CITY OF ALBUQUERQUE

Re: Eagle Vista Apartments
Grading and Drainage Plan
Engineer's Stamp dated 3-2-12 (B13/D002C)

DRAINAGE INFORMATION

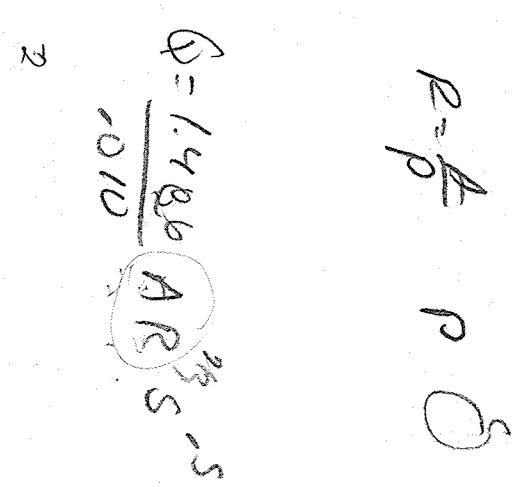
Inlet Calcs? Inverts
Depress landscaping Areas.
 curb opening sizes.
